Work Order ID 114477

DART AEROSPACE LTD	Work Order:	114477
Description: Crosstube High Aft (205/212)	Part Number:	D212-664-201
Inspection Dwg: D212-664-241 Rev: D		Page 1 of 1

DRAWING NO. D212-664-241	TITLE CROSSTUBE ASSY (205/212 HI AFT)	REV. D	DART AEROSPACE LTD ENGINEERING ORDER		D.E.O. NO. D212-664-241-D-1	SHEET NO. SHEET 1 OF 2	SCALE NTS
DRAWN	CHECKED	MFG. APPR.	APPROVED	DE APPR.			
DATE 11.04.07	DATE 11.04.11	DATE 11.04.12	DATE 11/04/12	DATE 11.04.12

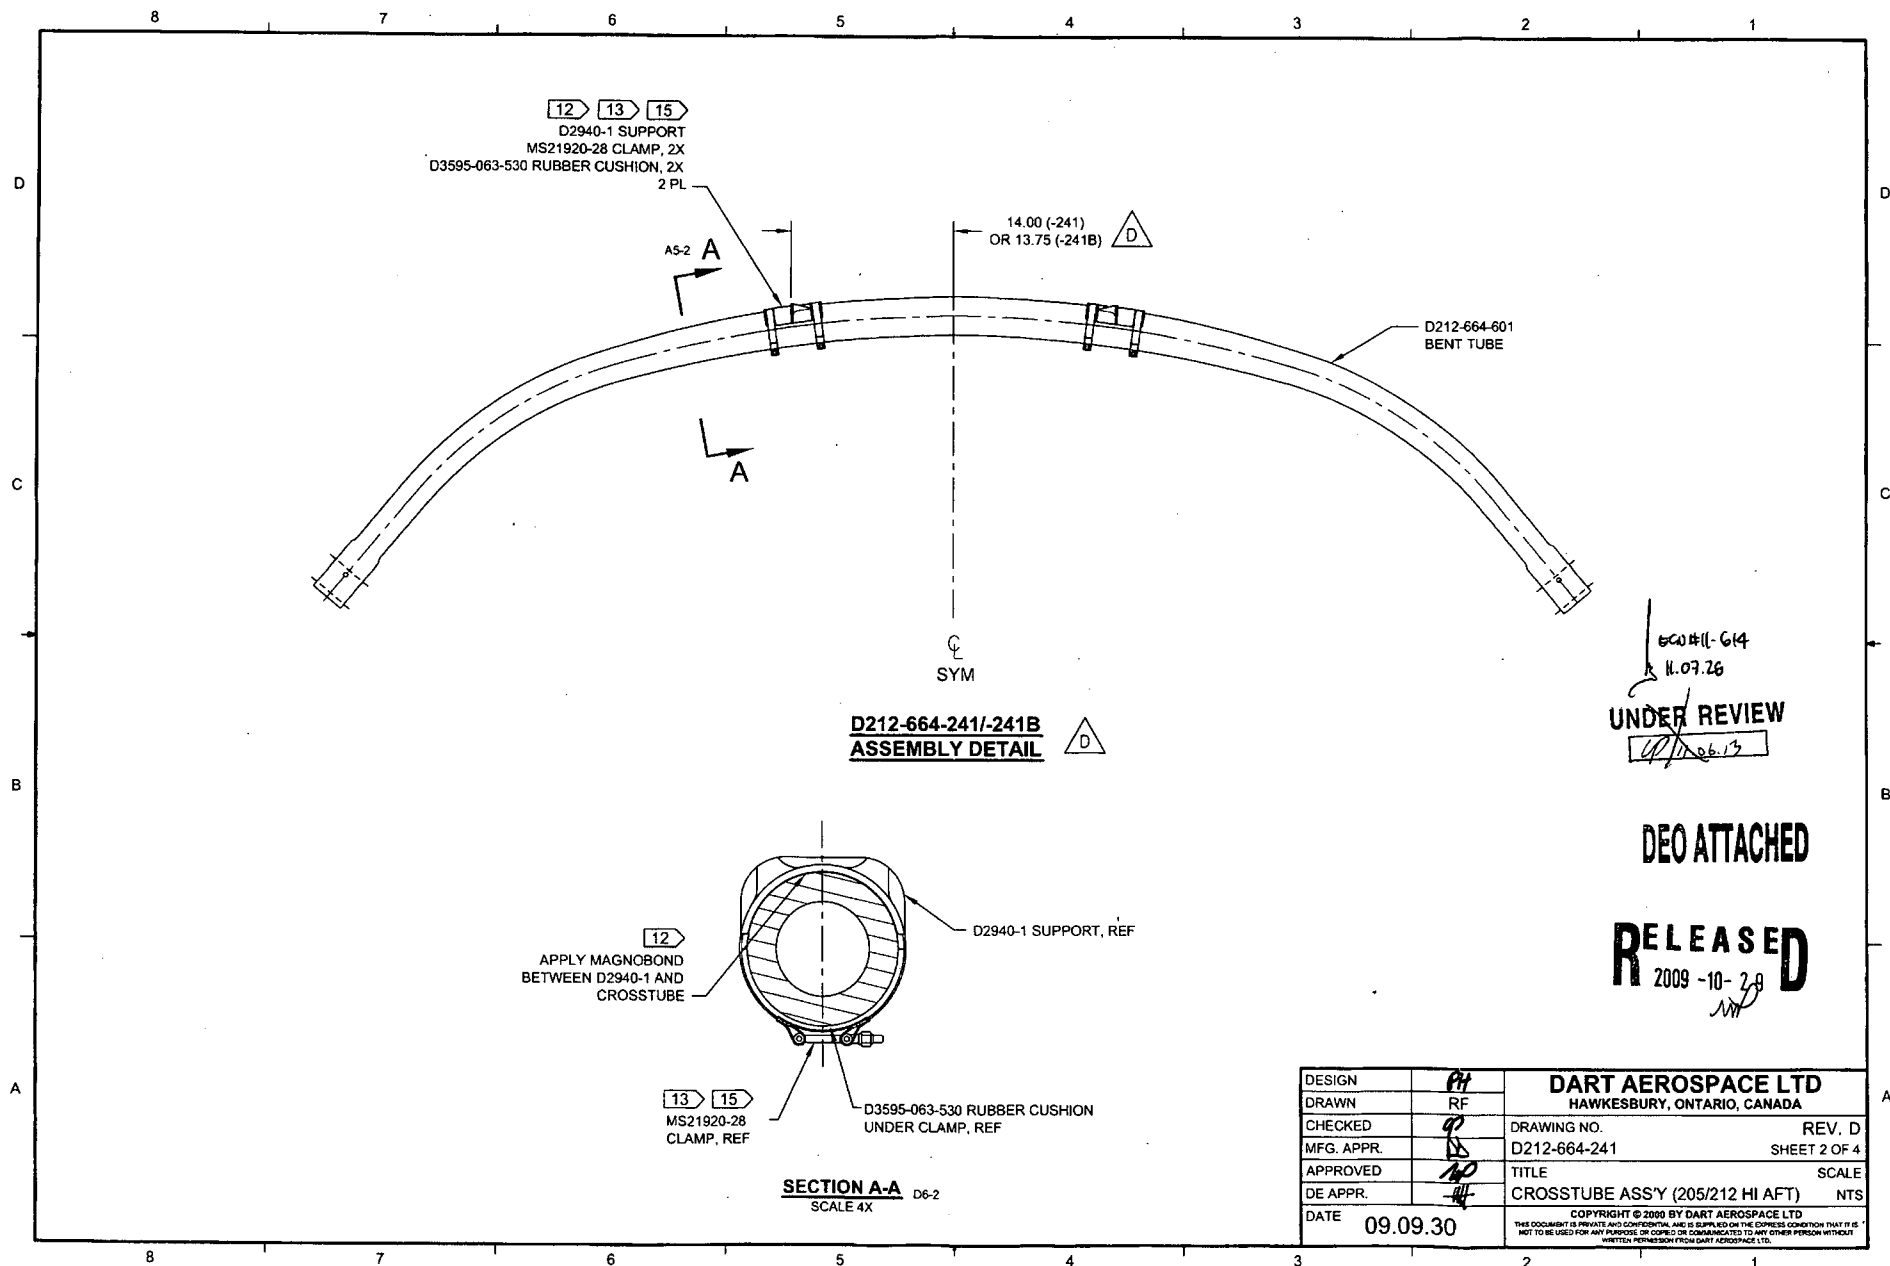
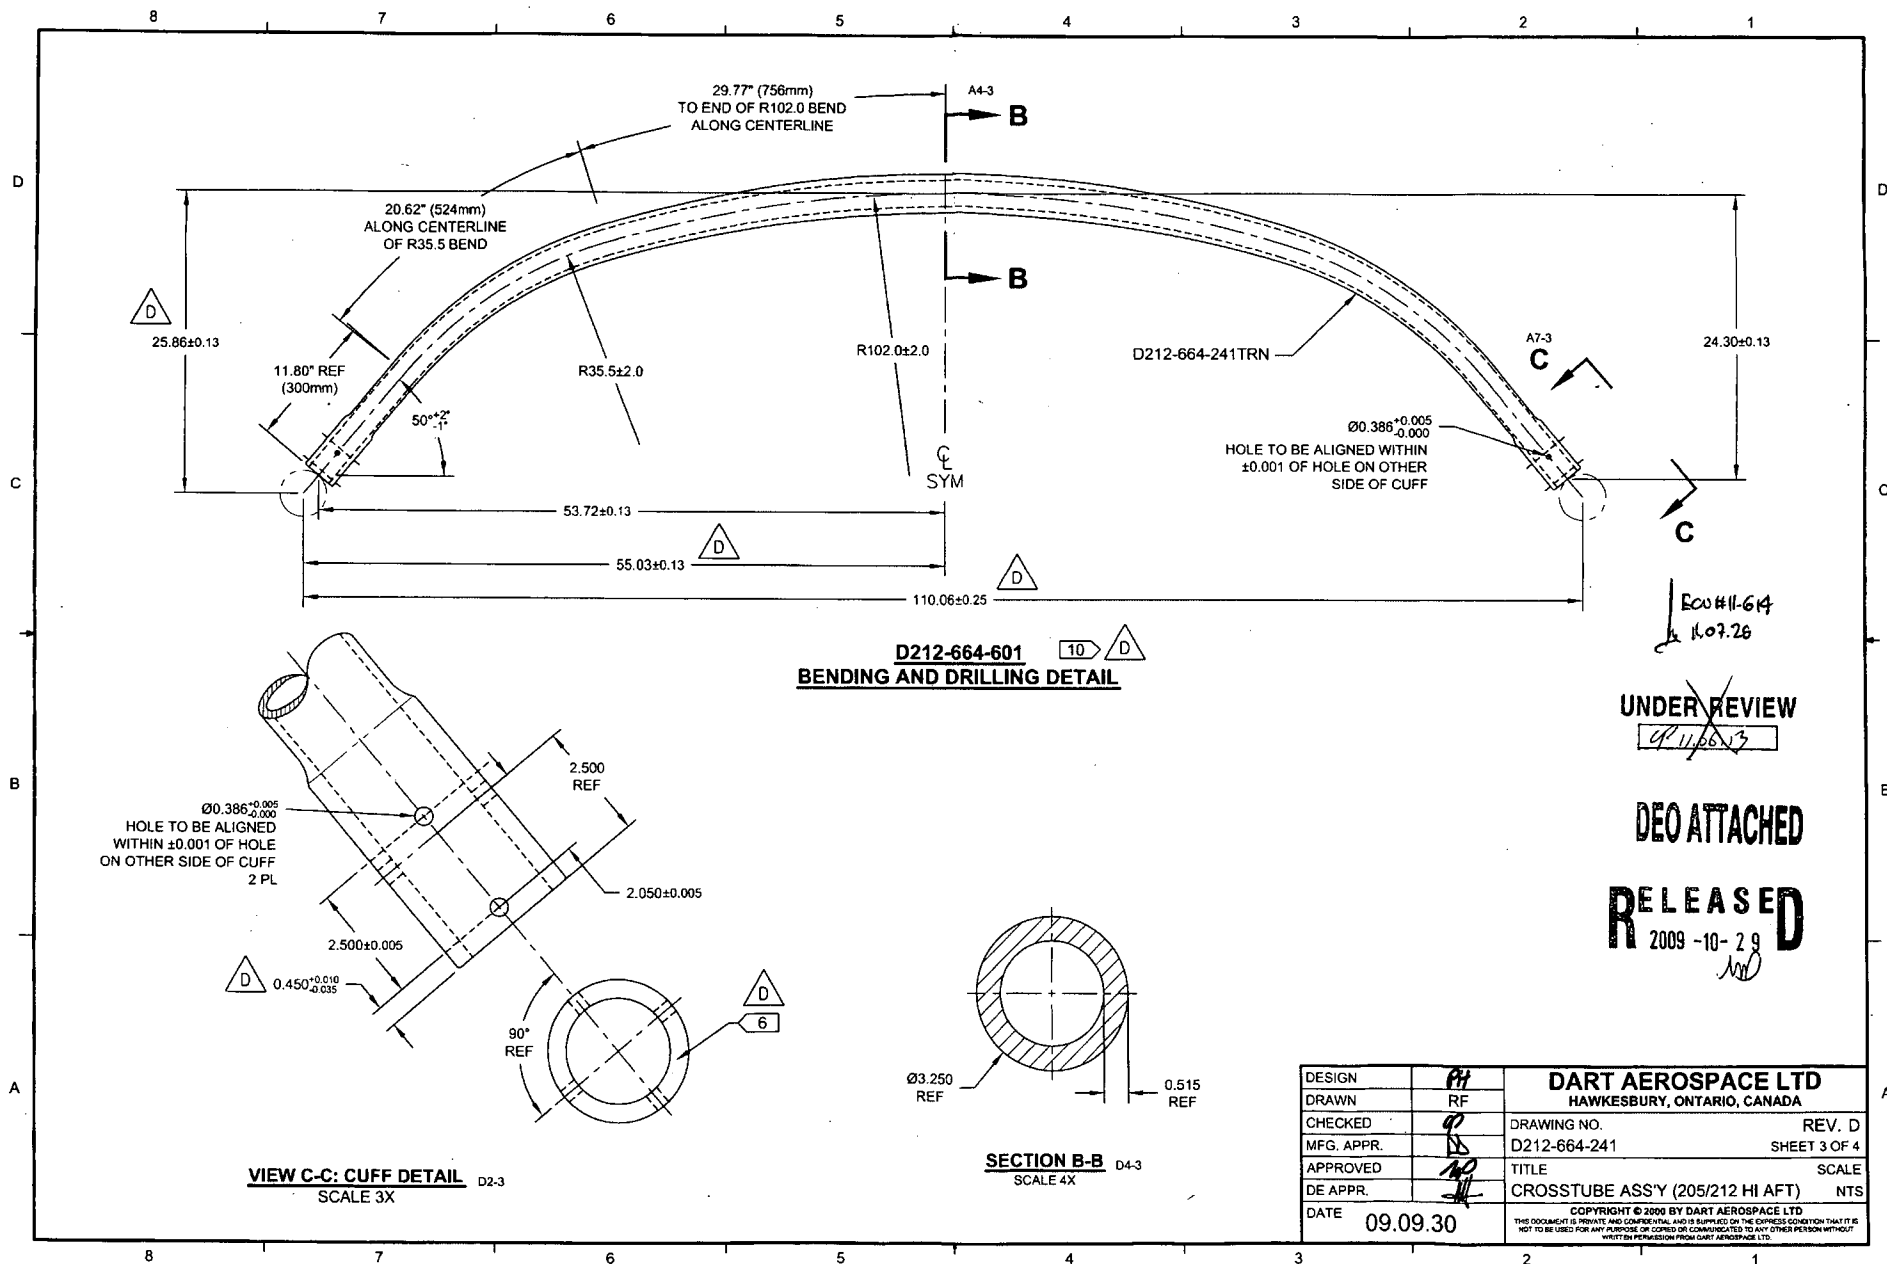
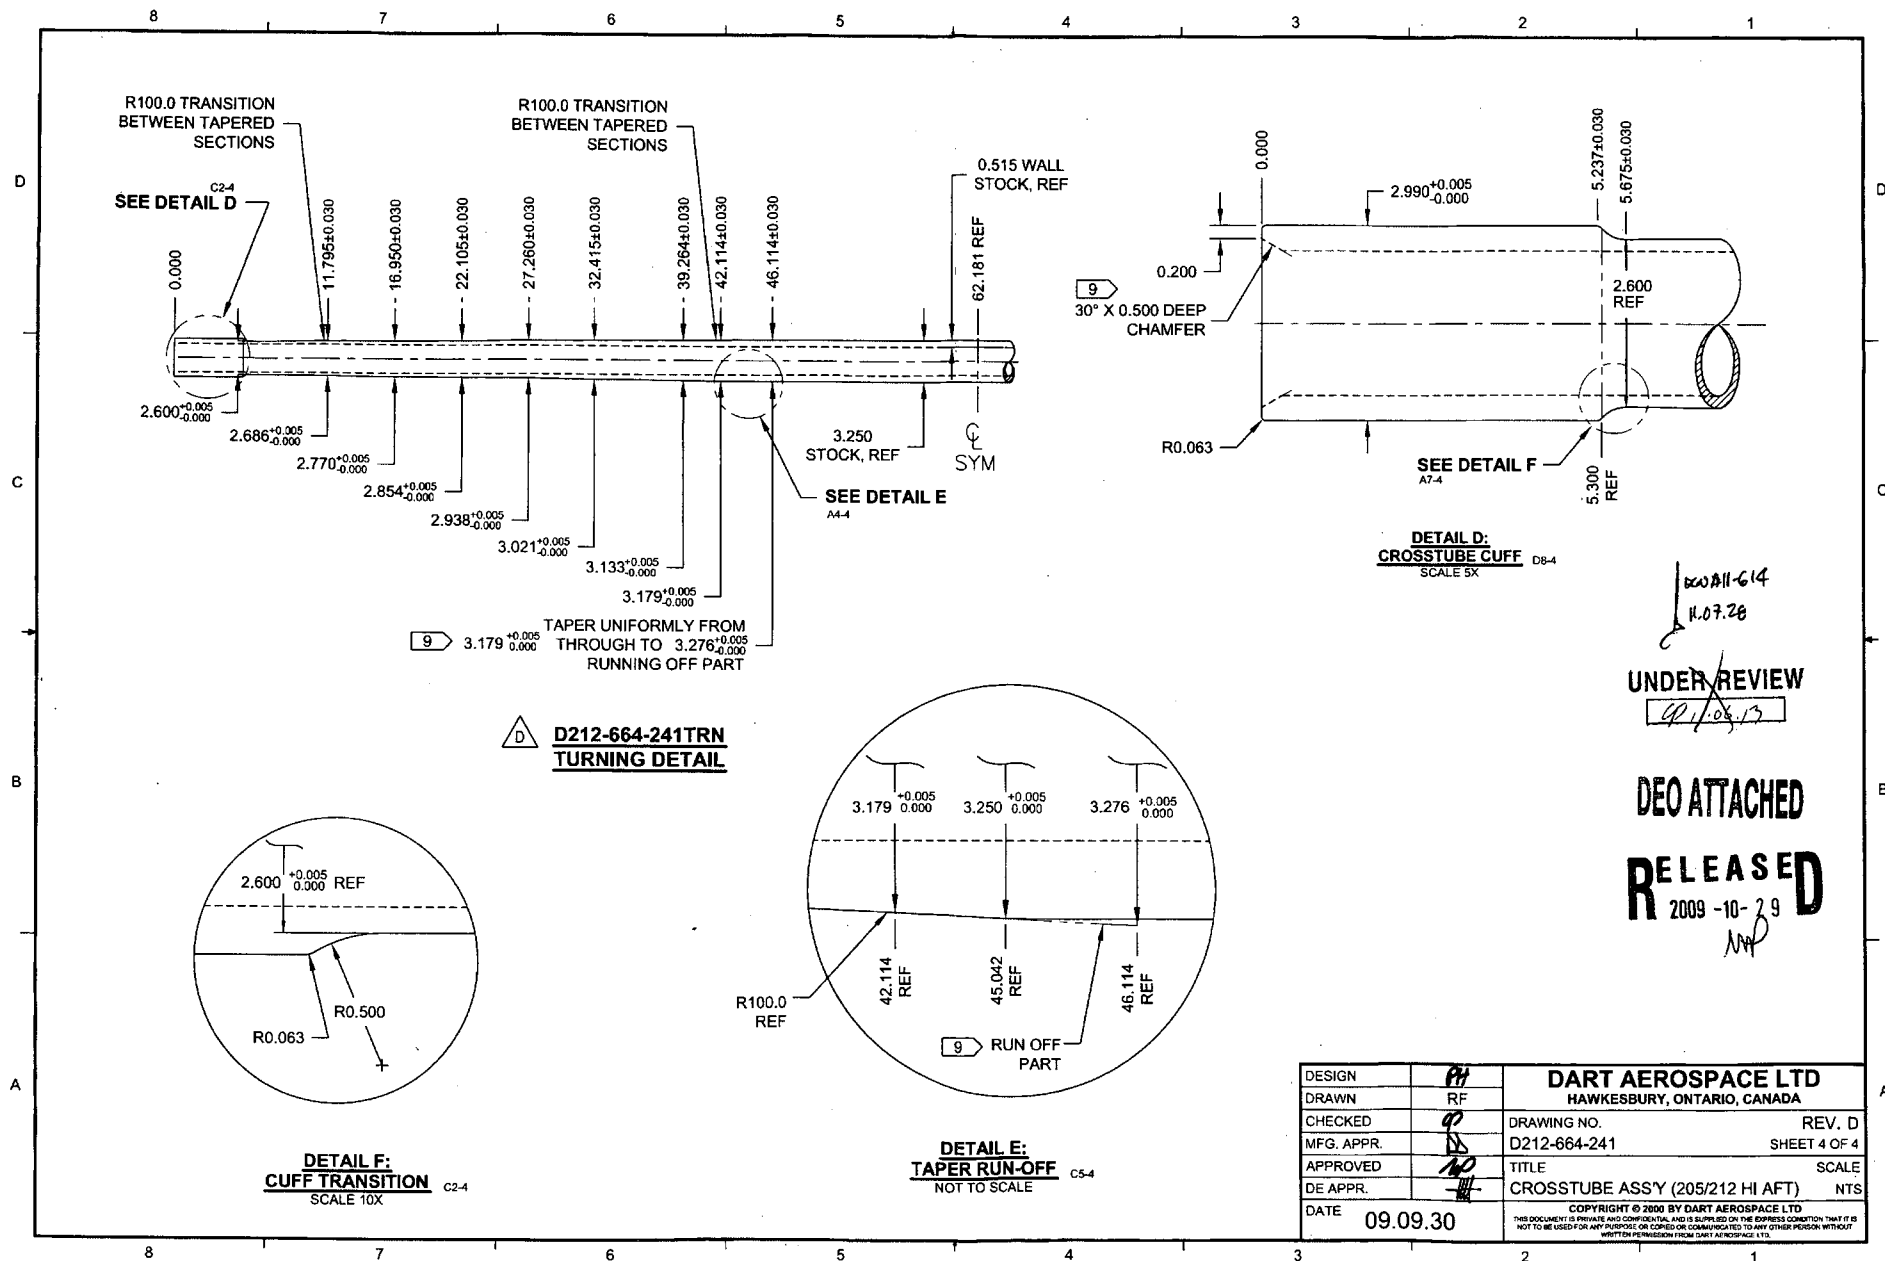
PURPOSE:

ADD AN INSPECTION WINDOW TO UNDERSIDE OF CROSSTUBE.

- 2) FINISH: CHEMICAL CONVERSION COAT PER DART QSI 005 4.1
PRIME INSIDE AND OUTSIDE PER DART QSI 005 4.2
MASK UNDERSIDE OF CROSSTUBE AS SHOWN (HATCHED AREA) AND
PAINT OUTSIDE PER DART QSI 005 4.2
REMOVE MASKING AND APPLY CLEAR COAT

**D212-664-241/-241B
ASSEMBLY DETAIL**

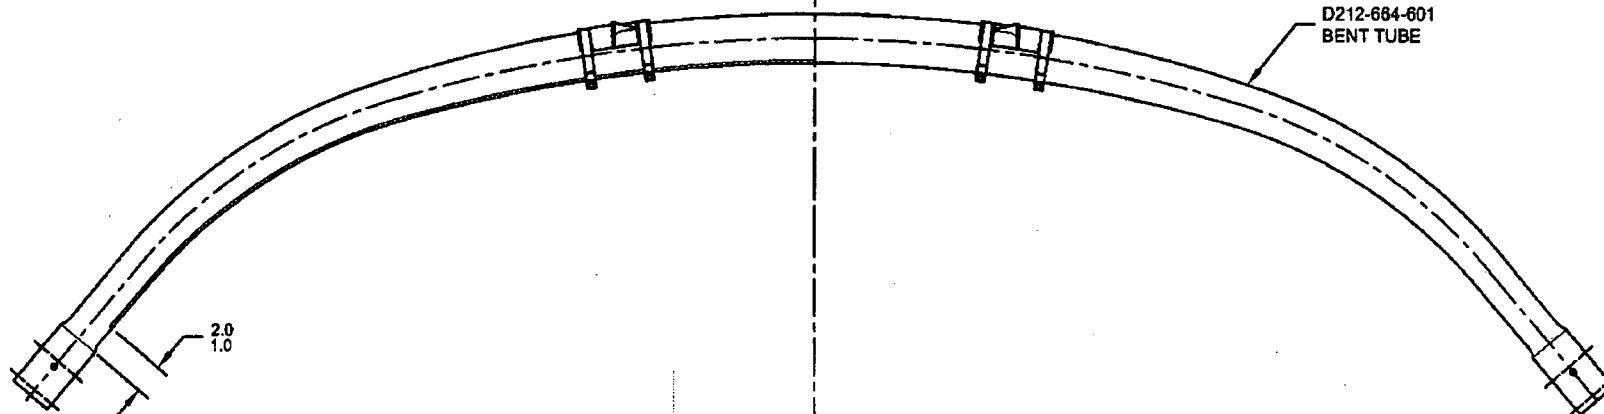
NOTES 2 OF SHEET 1 IS AMENDED AS FOLLOWS:

MASK AREA PRIOR TO PAINTING,
REMOVE MASKING AFTER PAINT
AND APPLY CLEAR COAT
